**RE: Sundance Construction – Beverly Hills
Grading and Drainage Plan
Engineer’s Stamp Date: 01/24/18
Hydrology File: B18D023**

Based upon the information provided in your submittal received 01/24/18, the Grading and Drainage Plan **is not** approved for Building Permit. The following comments need to be addressed for approval of the above referenced project:

C-101

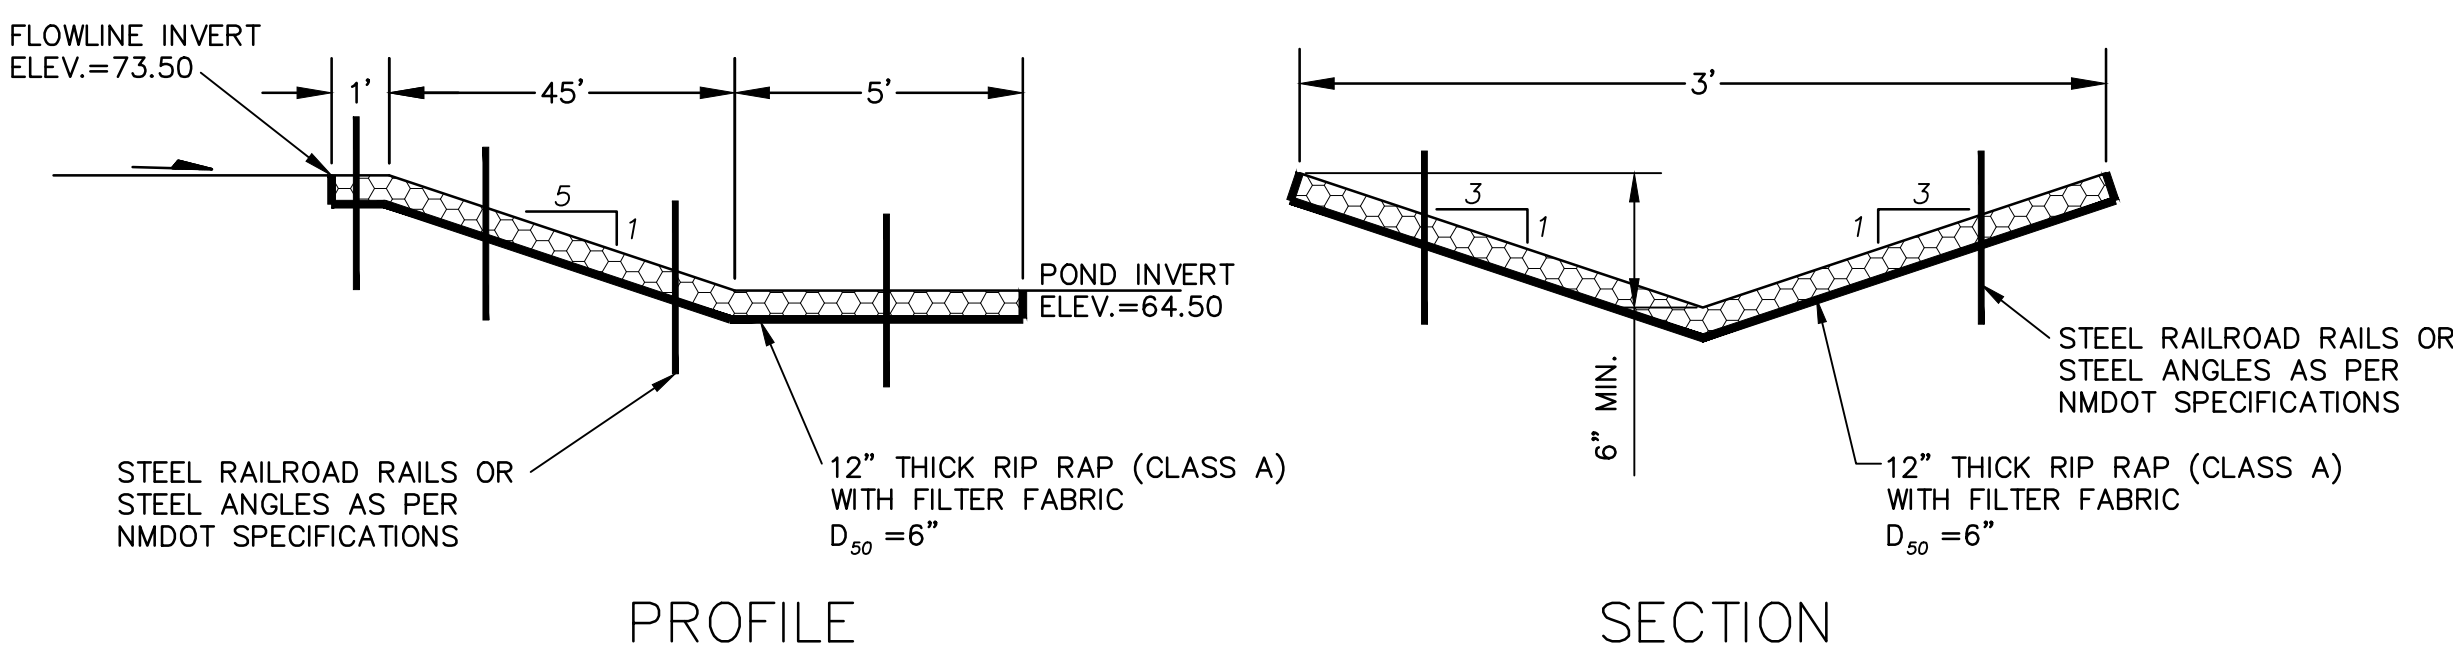
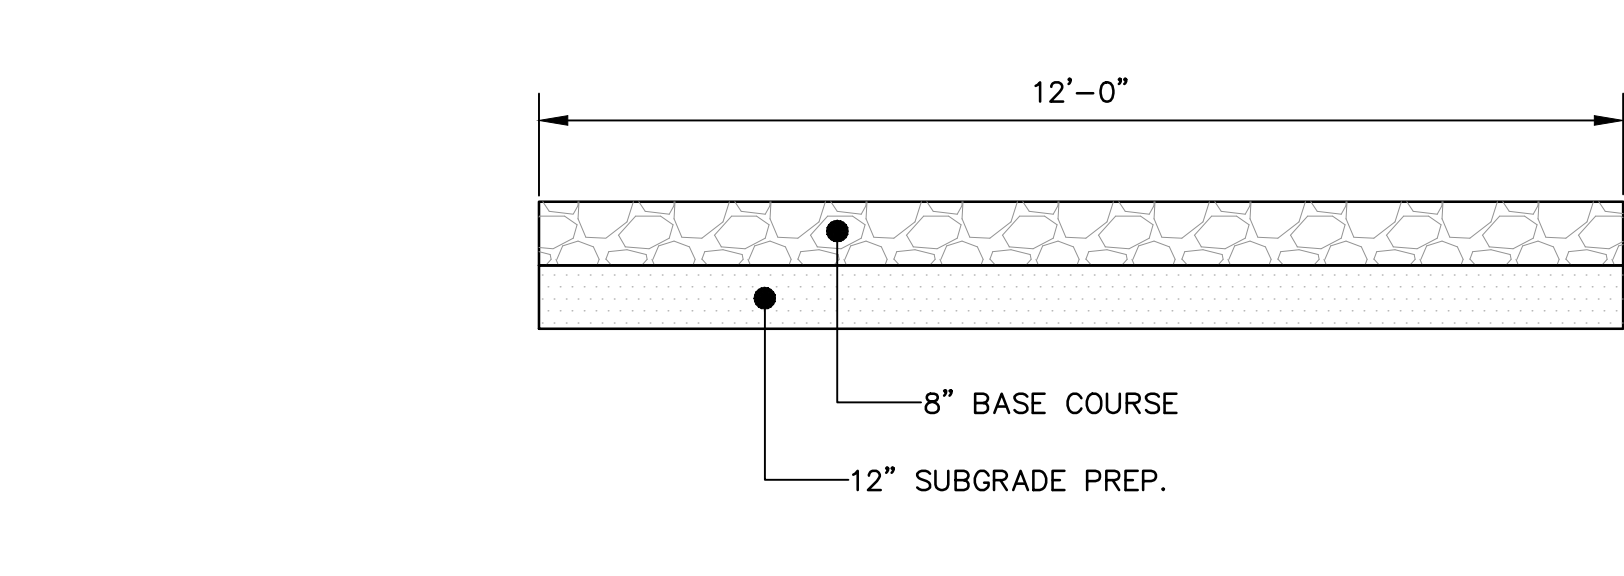
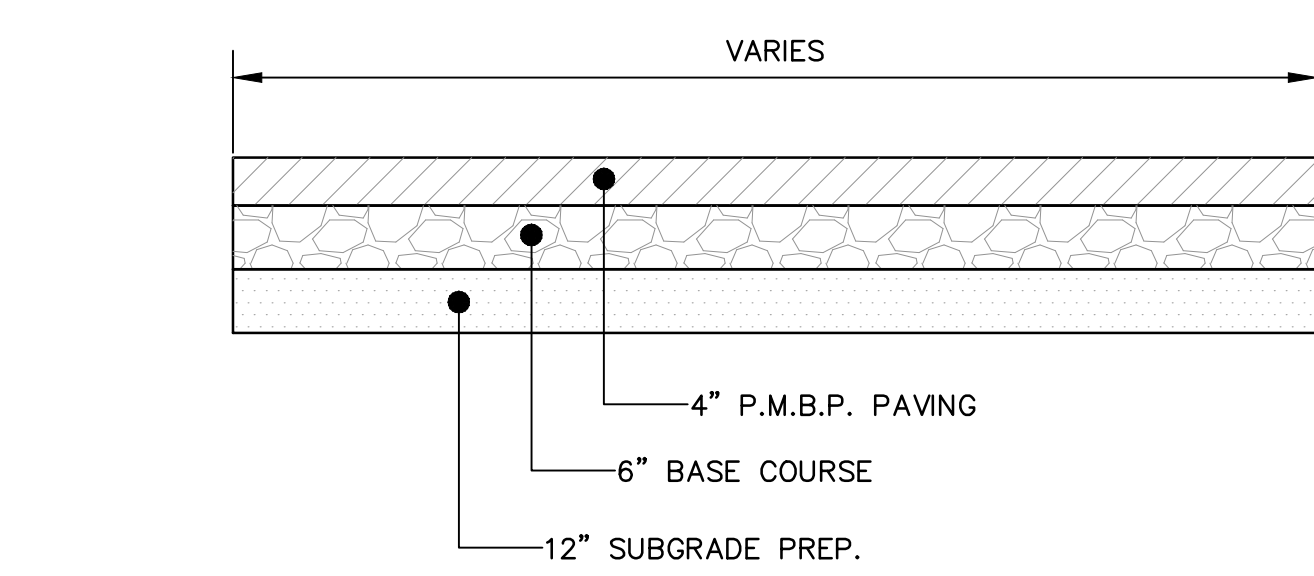
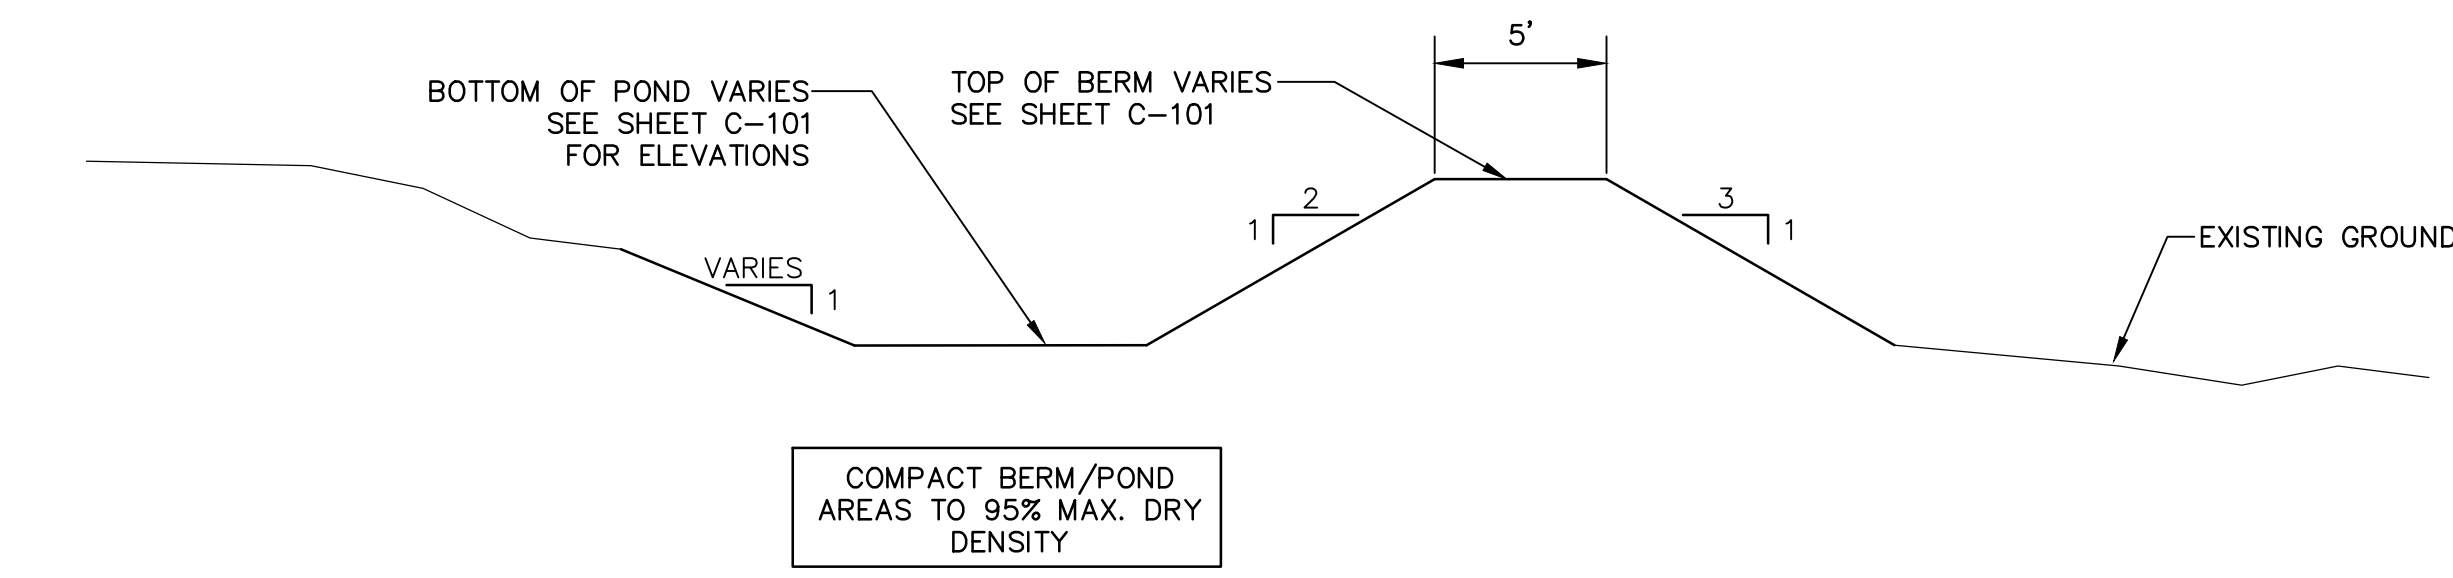
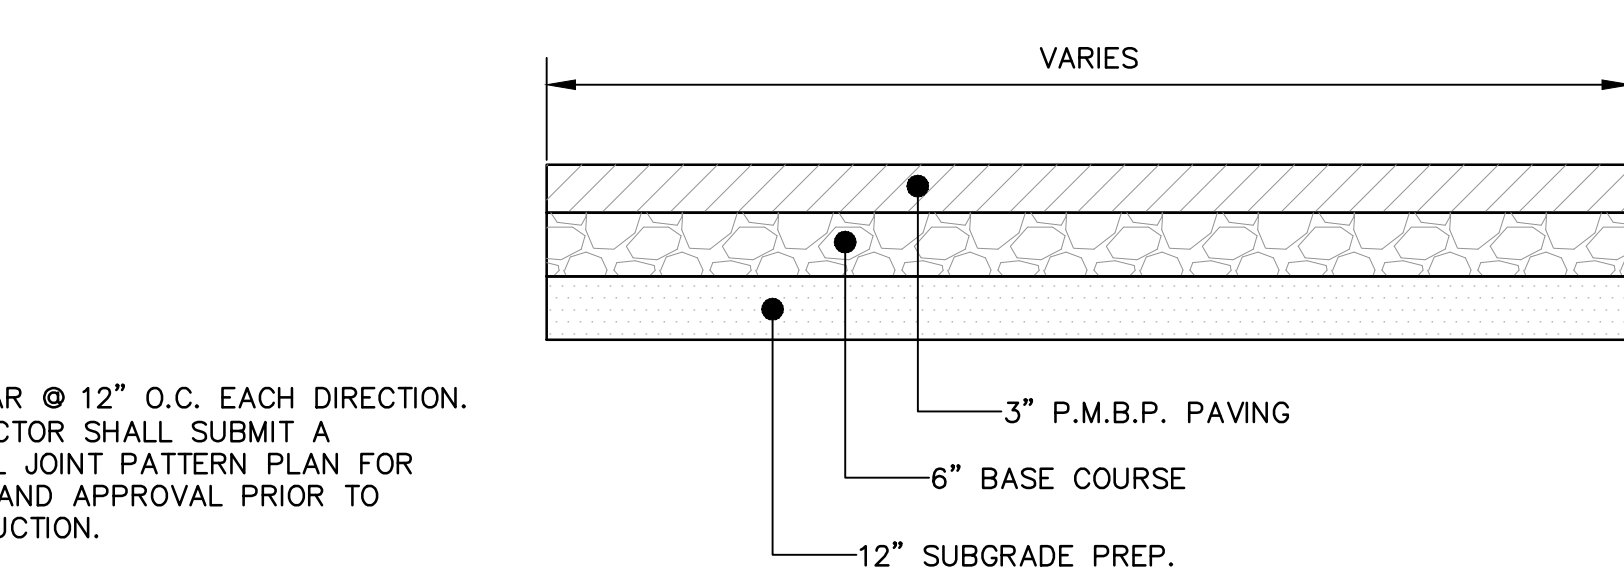
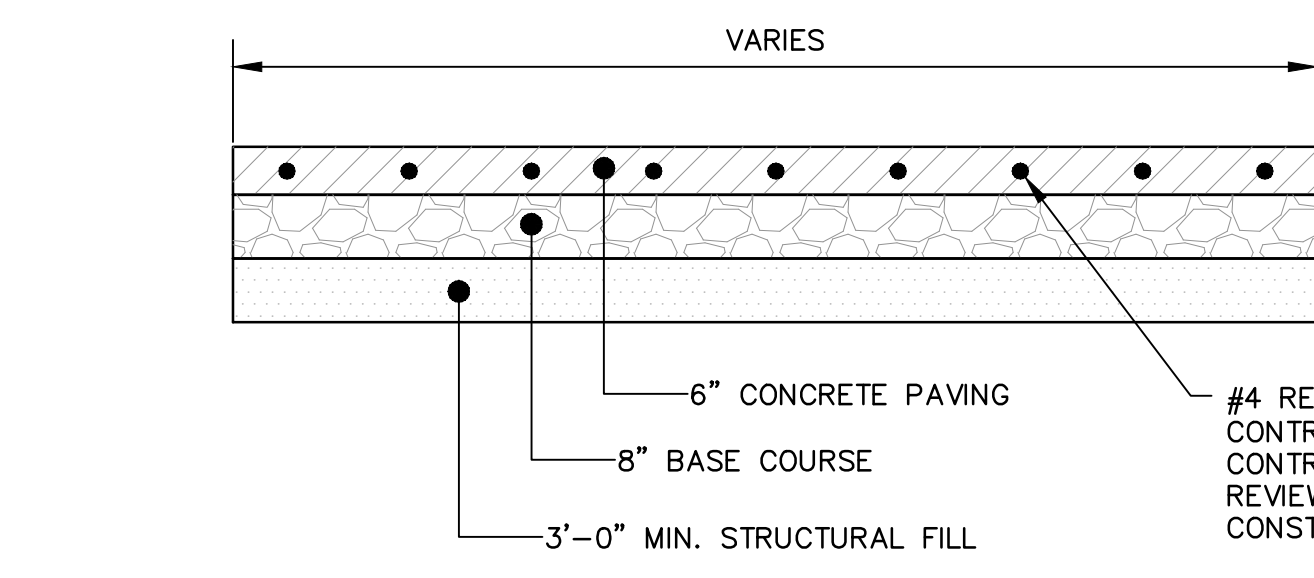
3. Sheet C-101. Please provide a written agreement from Lot 28 property Owner stating that grading can be conducted on their property for the benefit of Lot 29. If an agreement cannot be obtained, then the swale to divert off-site drainage to Beverly Hills will have to be within the project’s boundary.

4. Sheet C-101. Please add the flowline information at the start of the diversion swale at the east side of the property.

5. Sheet C-101. Key Note 22. This pond is just pointing to an open area. Is there supposed to be a first flush pond here?? It appears that all first flush volume is included in the pond to the southwest corner of the property.

8. Sheet C-101. Please show the half street, storm drain, and inlet which is to be constructed with the work order. Please add a note that all work within Beverly Hills Ave will be part of Work Order #722084.
